COLORADO DIVISION OF RECLAMATION, MINING AND SAFETY
MINERALS PROGRAM INSPECTION REPORT
PHONE: (303) 866-3567

MINE NAME: Fedinec Pit	MINE/PROSPECTING ID#: M-1977-057	MINERAL: Crushed stone mater	COUNTY: Moffat
INSPECTION TYPE: Monitoring	INSPECTOR(S): Dustin M. Czapl	INSP. DATE: March 27, 2012	INSP. TIME: 14:45
OPERATOR: Pioneer Sand Company Inc	OPERATOR REPRESENTATIVE: Shane Ridenour	TYPE OF OPERATION: 110c - Construction Limited Impact	
REASON FOR INSPECTION: Normal I&E Program	BOND CALCULATION TYPE: Complete Bond	BOND AMOUNT: \$15,500.00	
DATE OF COMPLAINT: NA	POST INSP. CONTACTS: None	JOINT INSP. AGENCY: None	
WEATHER: Clear	INSPECTOR'S SIGNATURE: 	SIGNATURE DATE: April 5, 2012

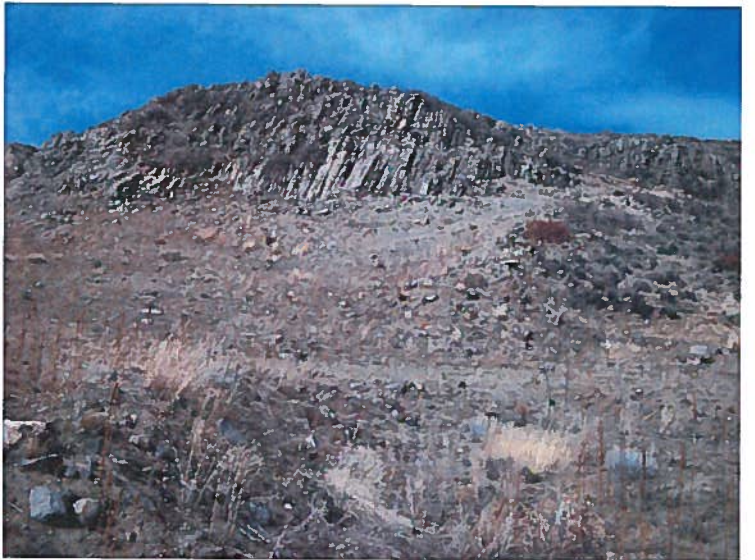
Adequate mine identification signage was noted at the entrance to the site.
